**Economic and Social Council**

**World Forum for Harmonization of Vehicle Regulations**

**Draft Regulation on pedestrian safety****Proposal for the 01 series amendments to draft Regulation on pedestrian safety****Submitted by the expert from Japan\***

**Lower legform II; dimensions and C.G. locations of femur, knee joint and tibia (Side view)**

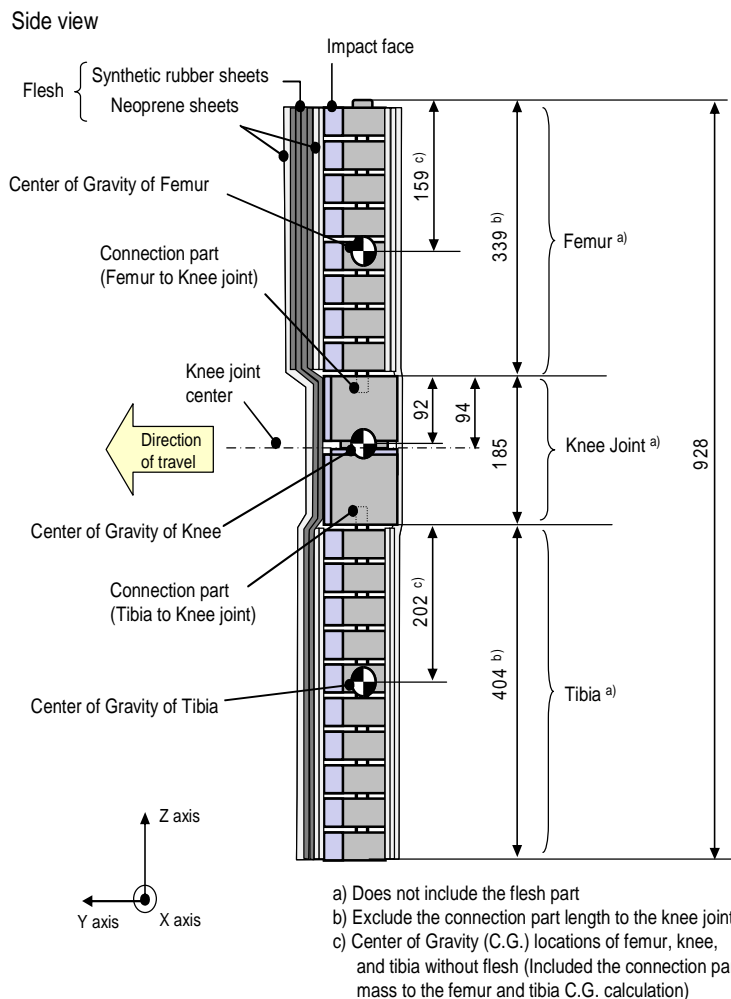
- "1.1. The Lower legform II shall consist of flesh, flexible long bone segments (representing femur and tibia), and a knee joint as shown in Figure 1.

- The overall length of the impactor shall be  $928 \pm 3$  mm, having a required mass of  $13.2 \pm 0.7$  kg including flesh. The length of the femur, knee joint, and tibia shall be  $339 \pm 2$  mm,  $185 \pm 1$  mm, and  $404 \pm 2$  mm respectively. The knee joint centre position shall be  $94 \pm 1$  mm from the top of the knee joint.

The centre of gravity of the femur and tibia without flesh, including the connection part to the knee joint, shall be  $159 \pm 8$  mm and  $202 \pm 10$  mm respectively from the top, but not including the connection part to the knee joint, of each part as shown in Figure 1. The centre of gravity of the knee shall be  $92 \pm 5$  mm from the top of the knee joint as shown in Figure 1.

Figure 2  
**Lower legform II; femur, tibia, and knee dimensions (Top view)**

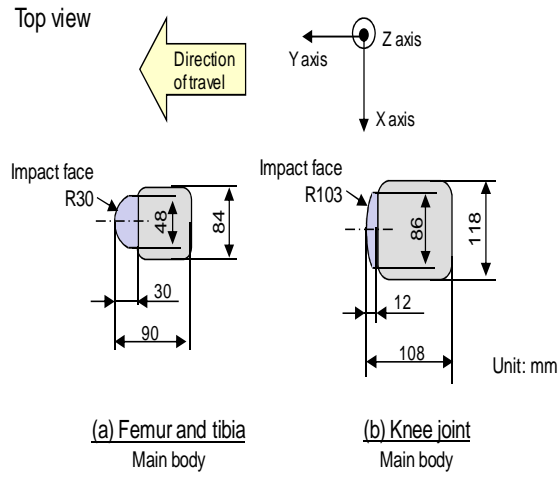
- 1.2. The cross-sectional shape perpendicular to the Z-axis of the femur and tibia main bodies shall be  $90 \pm 2$  mm in width along the Y-axis, and  $84 \pm 1$  mm in width along the X-axis as shown in Figure 2 (a). The impact face shall be  $30 \pm 1$  mm in radius,  $30 \pm 1$  mm in width along the Y-axis, and  $48 \pm 1$  mm in width along the X-axis as shown in Figure 2 (a).

- 1.3. The cross-sectional shape perpendicular to the Z-axis of the knee joint shall be  $108 \pm 2$  mm in width along the Y-axis, and  $118 \pm 1$  mm in width along the X-axis as shown in Figure 2 (b). The impact face shall be  $103 \pm 1$  mm in radius,  $12 \pm 1$  mm in width along the Y-axis, and  $86 \pm 1$  mm in width along the X-axis as shown in Figure 2 (b).

Figure 3  
**Lower legform II: flesh dimensions**

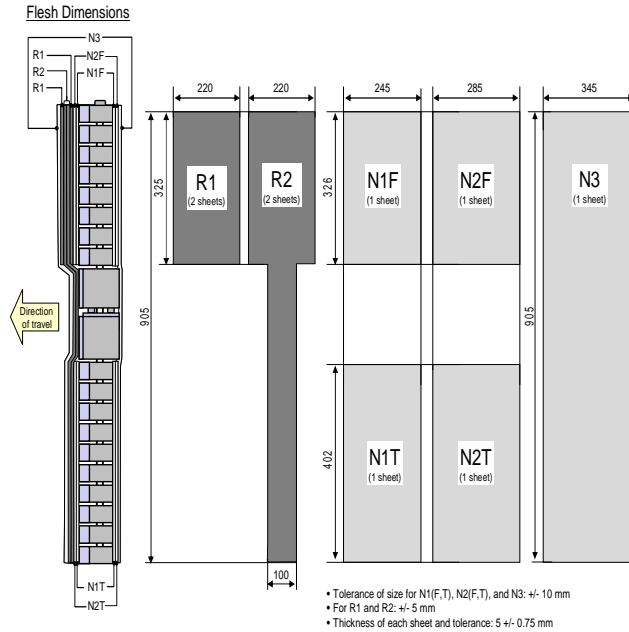
- 1.5. For each test, the impactor (femur, knee joint, and tibia) shall be covered by flesh composed of synthetic rubber sheets (R1, R2) and neoprene sheets (N1F, N2F, N1T, N2T, N3) as shown in Figure 3. The sheets are required to have a compression characteristic as shown in Figure 4. The compression characteristic shall be checked using the same batch of sheets as those used for the impactor flesh. The size of the sheets shall be within the requirements described in Figure 3.

Figure 5  
**Lower legform II; instrument locations**

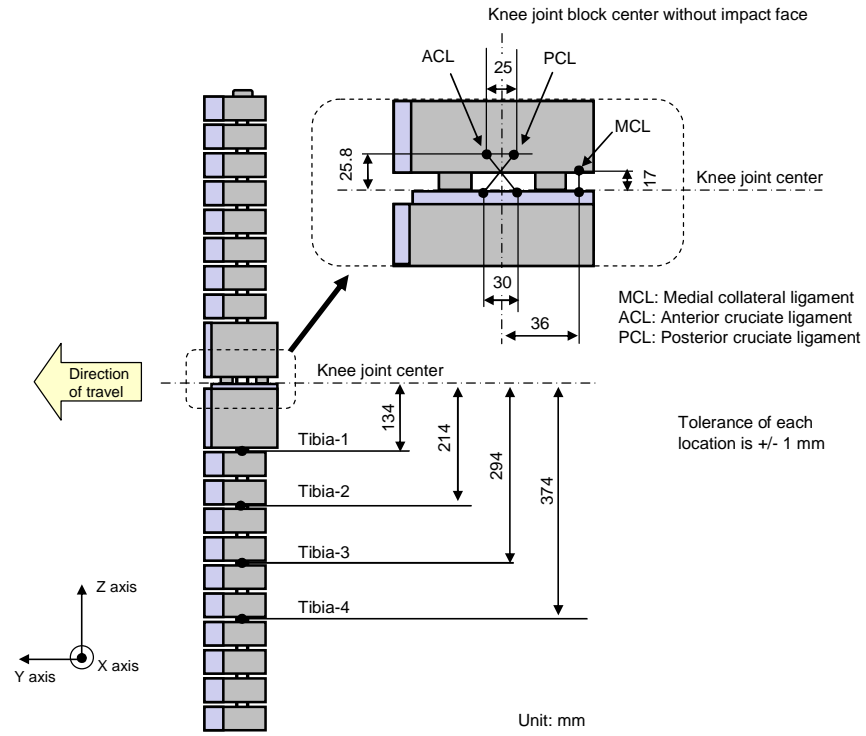
2. Lower legform II instrumentation
  - 2.1. Four transducers shall be installed in the tibia to measure bending moments applied to the tibia. The sensing locations of each of the transducers are as follows: tibia-1:  $134 \pm 1$  mm, tibia-2:  $214 \pm 1$  mm, tibia-3:  $294 \pm 1$  mm, and tibia-4:  $374 \pm 1$  mm below the knee joint centre respectively as shown in Figure 5. The measurement axis of each transducer shall be the X-axis of the impactor.

- 2.2. Three transducers shall be installed in the knee joint to measure elongations of the medial collateral ligament (MCL), anterior cruciate ligament (ACL), and posterior cruciate ligament (PCL). The measurement locations of each transducer are shown in Figure 5. The measurement locations shall be within  $\pm 4$  mm along the X axis from the knee joint centre.

**Tolerances of angles for the Lower legform II at the time of the first impact (see paragraphs 1.4. and 1.7.)**

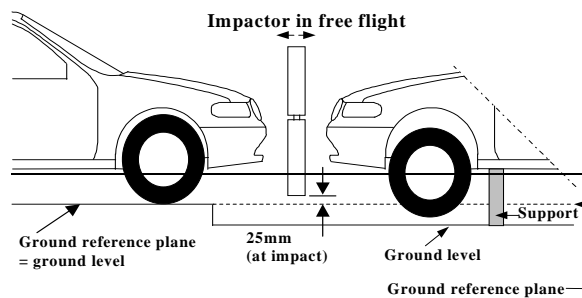
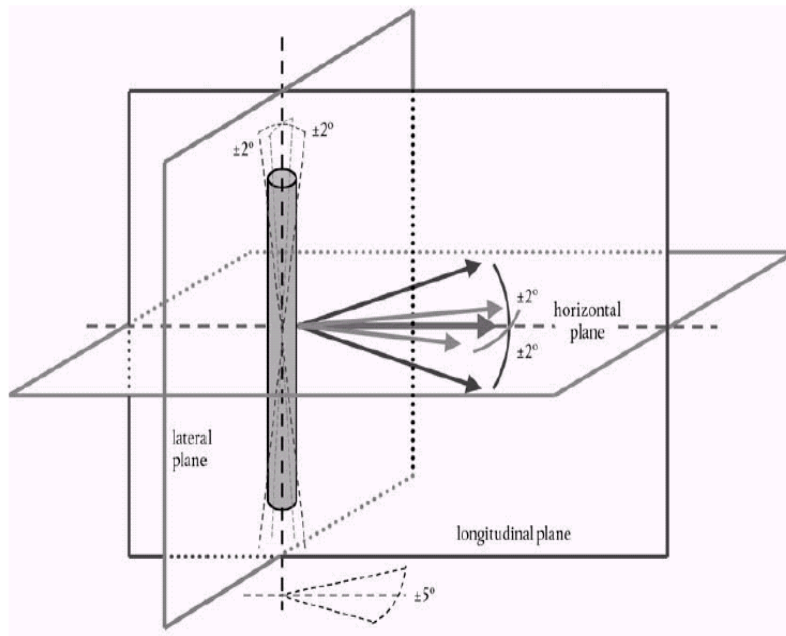
- 1.4. The direction of the impact velocity vector shall be in the horizontal plane and parallel to the longitudinal vertical plane of the vehicle. The tolerance for the direction of the velocity vector in the horizontal plane and in the longitudinal plane shall be  $\pm 2^\circ$  at the time of first contact. The axis of the impactor shall be perpendicular to the horizontal plane, with a roll and pitch angle tolerance of  $\pm 2^\circ$  in the lateral and longitudinal plane. The horizontal, longitudinal and lateral planes are orthogonal to each other (see Figure 1).**

**The impactor may be propelled by any means that can be shown to meet the requirements.**
- 1.7. At the time of first contact the impactor shall have the intended orientation about its vertical axis, for the correct operation of its knee joint, with a yaw angle tolerance of  $\pm 5^\circ$  (see Figure 1).**

Figure 2:  
 Lower legform II to bumper tests for complete vehicle in normal ride attitude (left) and for cut-body mounted on supports (right) (see paragraph 1.5.)

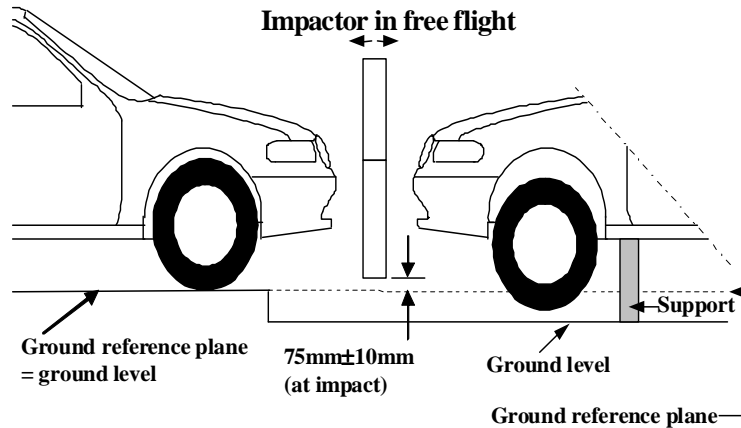
- 1.5. The bottom of the impactor shall be at 75 mm above ground reference plane at the time of first contact with the bumper (see Figure 2), with a  $\pm 10$  mm tolerance. When setting the height of the propulsion system, an allowance must be made for the influence of gravity during the period of free flight of the impactor.**

**Lower legform II requirement corridor of femur and tibia in static certification test (see paragraph 1.2.2.)**

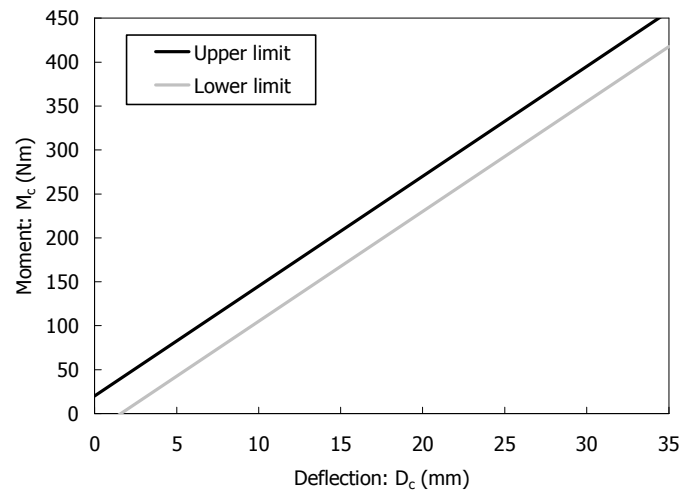
- 1.2.2. When the femur and tibia of the impactor are loaded in bending in accordance with paragraph 1.2.4., the applied moment and generated deflection at the centre of the femur and tibia ( $M_c$  and  $D_c$ ) shall be within the corridors shown in Figure 1.

Figure 2  
**Lower legform II requirement corridors for knee joint in static certification test (see paragraph 1.2.3.)**

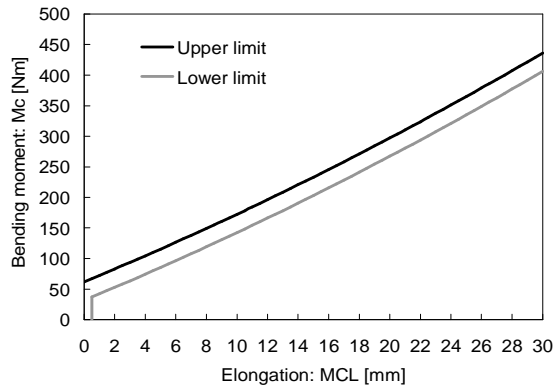
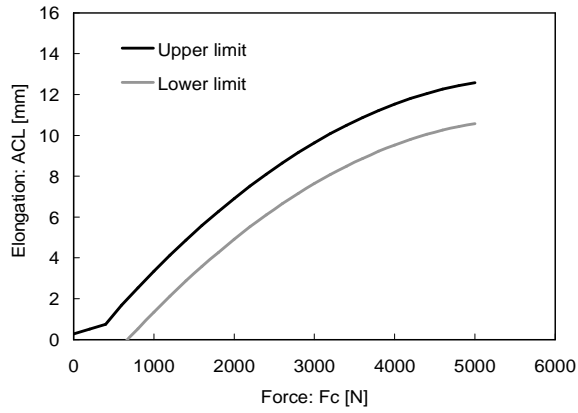
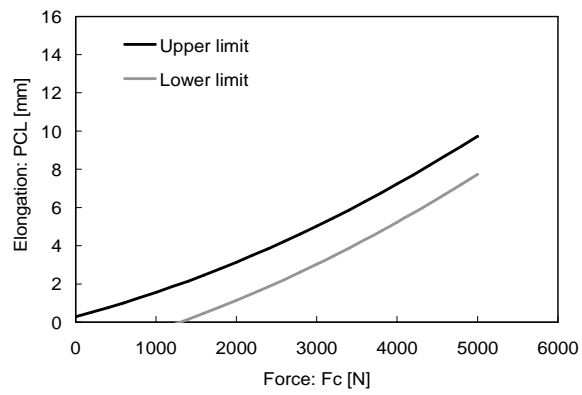
- 1.2.3. When the knee joint of the impactor is loaded in bending in accordance with paragraph 1.2.5., the MCL, ACL and PCL elongations and applied bending moment or force at the centre of the knee joint ( $M_c$  or  $F_c$ ) shall be within the corridors shown in Figure 2.

Figure 3  
 Lower legform II test set-up for femur in static certification tests (see paragraph 1.2.4.)

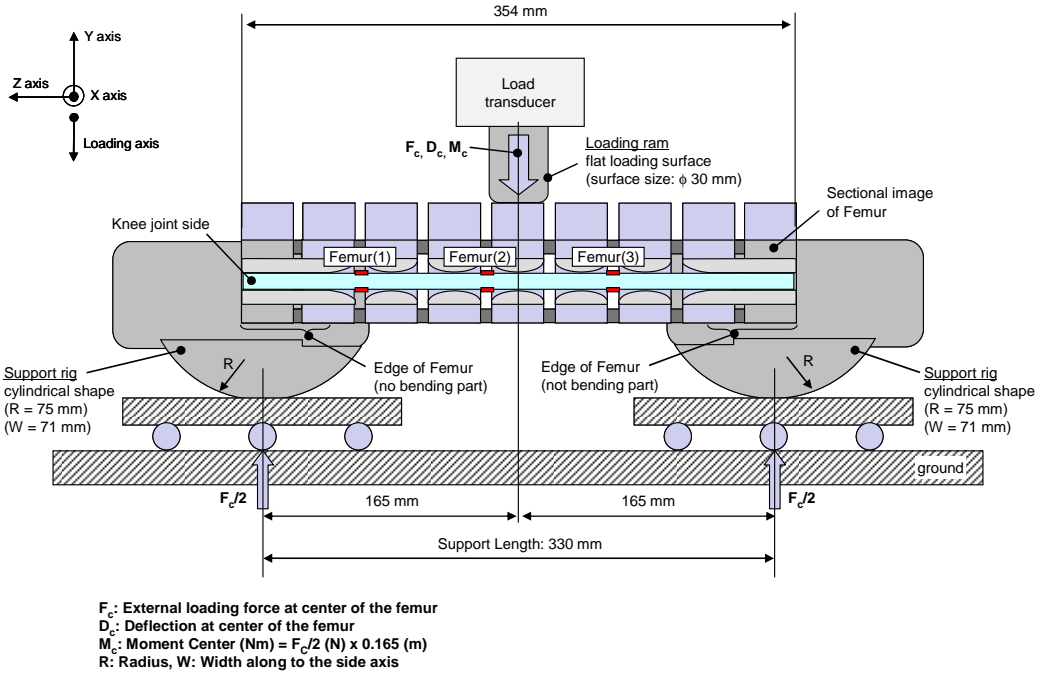
- 1.2.4. The edges of the femur and tibia, not bending parts, shall be mounted to the support rig firmly as shown in Figure 3 and Figure 4. The Y-axis of the impactor shall be parallel to the loading axis within  $180 \pm 2^{\circ}$  tolerance. In order to avoid friction errors, roller plates shall be set underneath the support rigs.

- The centre of the loading force shall be applied at the centre of the femur and tibia within  $\pm 2^{\circ}$  tolerance along the Z-axis. The force shall be increased at a rate between 10 and 100 mm/minute until the bending moment at the centre part ( $M_c$ ) of the femur or tibia reaches 400 Nm.

Figure 5:  
Lower legform II test set-up for knee joint in static certification test (see paragraph 1.2.5.)

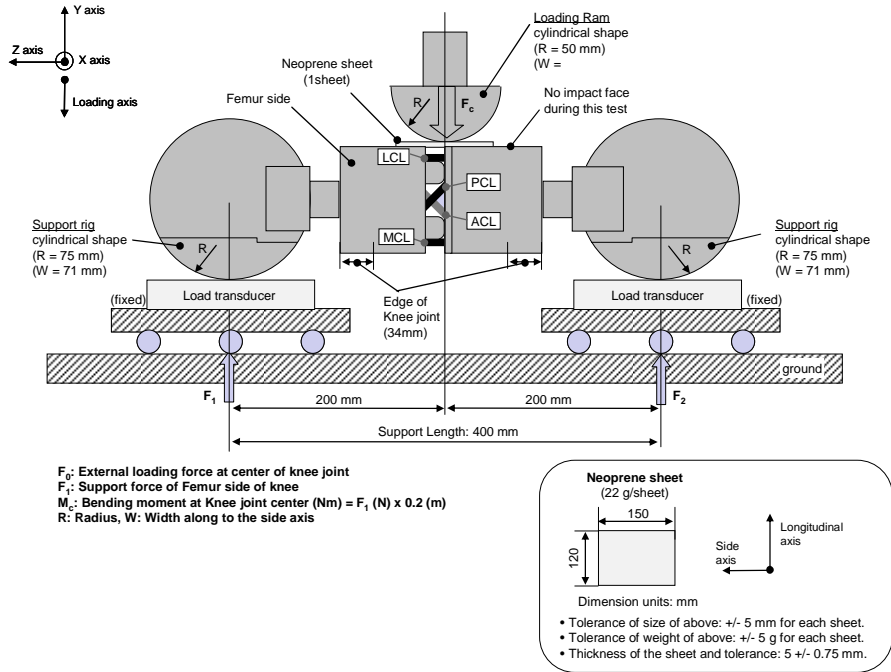
- 1.2.5. The edges of the knee joint, not bending parts, shall be mounted to the support rig firmly as shown in Figure 5. The Y-axis of the impactor shall be parallel to the loading axis within  $180 \pm 2^{\circ}$ . In order to avoid friction errors, roller plates shall be set underneath the support rigs. To avoid impactor damage, a neoprene sheet shall be set underneath the loading ram and the impactor face of the knee joint which is described in the Figure 2 of Annex 4 shall be removed. The neoprene sheet used in this test shall have compression characteristics as shown in Figure 4 of Annex 4.

- The centre of the loading force shall be applied at the centre of the knee joint within  $\pm 2^{\circ}$  tolerance along the Z-axis. The external load shall be increased at a rate between 10 and 100 mm/minute until the bending moment at the centre part of the knee joint ( $M_c$ ) reaches 400 Nm.

Figure 6  
Lower legform II test set-up for dynamic lower legform impactor certification test, Pendulum type (see paragraph 1.3.4.).

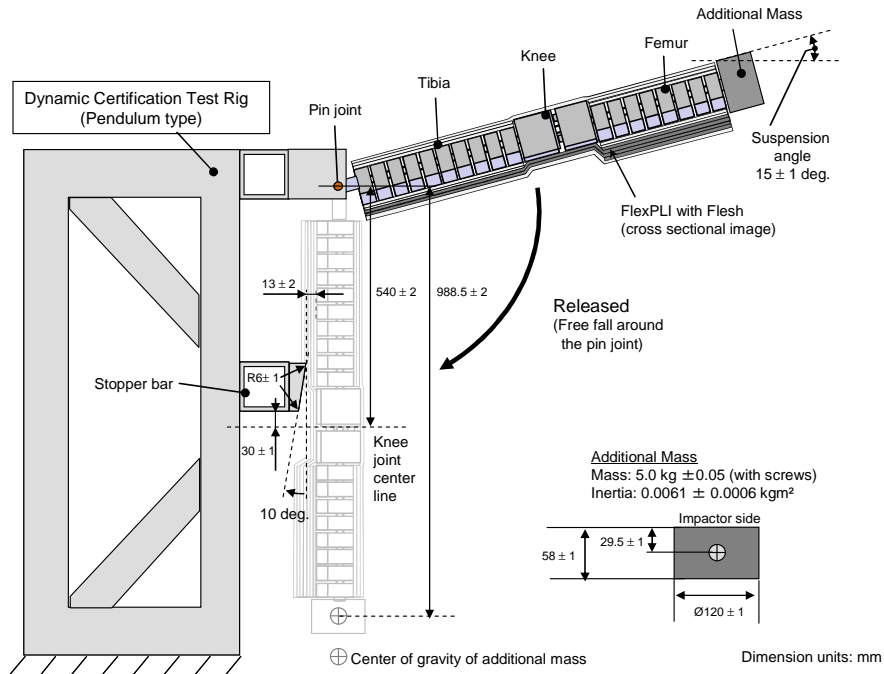
- 1.3.4. Test procedure
- 1.3.4.1. The impactor, including flesh, shall be suspended from the dynamic certification test rig  $15 \pm 1^\circ$  upward from the horizontal as shown in Figure 6. The impactor shall be released from the suspended position, whereupon the impactor falls freely against the pin joint of the test rig as shown in Figure 6.

- 1.3.4.2. The knee joint centre of the impactor shall be  $30 \pm 1$  mm below the bottom line of the stopper bar, and the tibia impact face without flesh shall be located  $13 \pm 2$  mm from the front upper edge of the stopper bar when the impactor is hanging freely as shown in Figure 6.

Figure 7  
**Lower legform II test set-up for dynamic lower legform impactor certification test, Inverse type**  
 (see paragraph 1.4.4.).

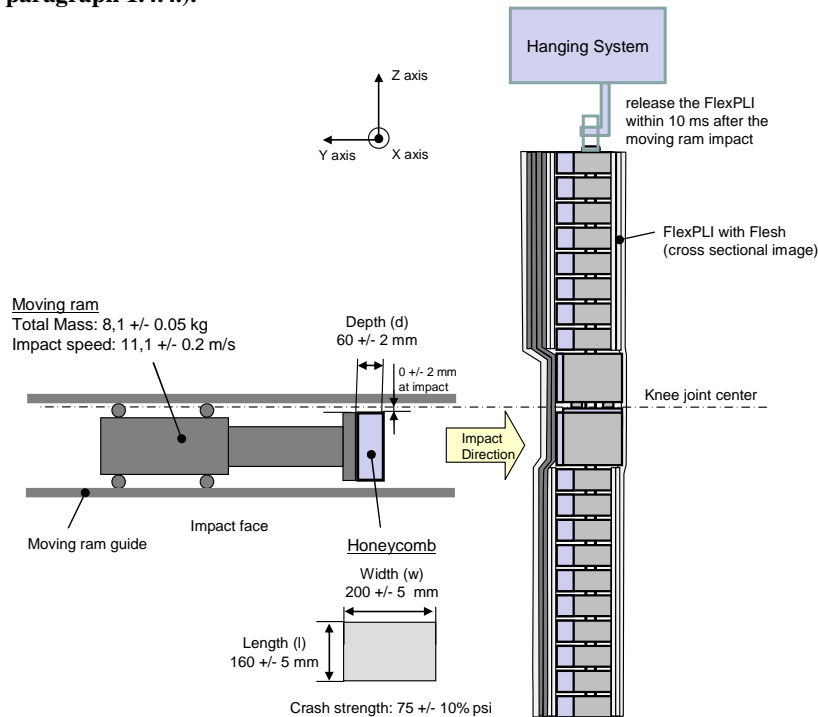
- 1.4.4. Test procedure
- 1.4.4.1. The fully assembled Lower legform II (with flesh and skin) shall be stationary suspended vertically from a test rig as shown in Figure 7. It is then impacted by the upper edge of a linearly guided Al honeycomb impactor, covered by a thin (less than 1 mm thickness) paper cloth, at an impact speed of  $11.1 \pm 0.2$  m/s. The legform is to be released from the test rig within 10 ms after the time of first contact to ensure a free flight condition.

- 1.4.4.2. The honeycomb of 5052 alloy, which is attached in front of the moving ram, shall have a crush strength of 75 psi  $\pm$  10 per cent and dimensions of  $w = 200 \pm 5$  mm,  $l = 160 \pm 5$  mm and  $d = 60 \pm 2$  mm. To ensure a consistent and good level of repeatability, the honeycomb should either have a 3/16 inches cell size or a 1/4 inch cell size. The honeycomb should have a density of 2.0 pcf in combination with a 3/16 inch cell size or a density of 2.3 pcf in combination with a 1/4 inch cell size.

- 1.4.4.3. The upper edge of the honeycomb face is to be in line with the rigid plate of the linearly guided impactor. At time of first contact, the upper edge of the honeycomb is to be in line with the knee joint centre line within a vertical tolerance of  $0 \pm 2$  mm. The honeycomb shall not be deformed before the impact test.

- 1.4.4.4. The Lower legform II pitch angle and therefore the pitch angle of the velocity vector of the honeycomb impactor (rotation around Y-axis) at the time of first contact shall be within a tolerance of  $0 \pm 2^\circ$  in relation to the lateral vertical plane. The Lower legform II roll angle and therefore the roll angle of the honeycomb impactor (rotation around X-axis) at the time of first contact shall be within a tolerance of  $0 \pm 2^\circ$  in relation to the longitudinal vertical plane. The Lower legform II yaw angle and therefore the yaw angle of the velocity vector of the honeycomb impactor (rotation around Z-axis) at the time of first contact shall be within a tolerance of  $0 \pm 2^\circ$ , to ensure a correct operation of the knee joint."
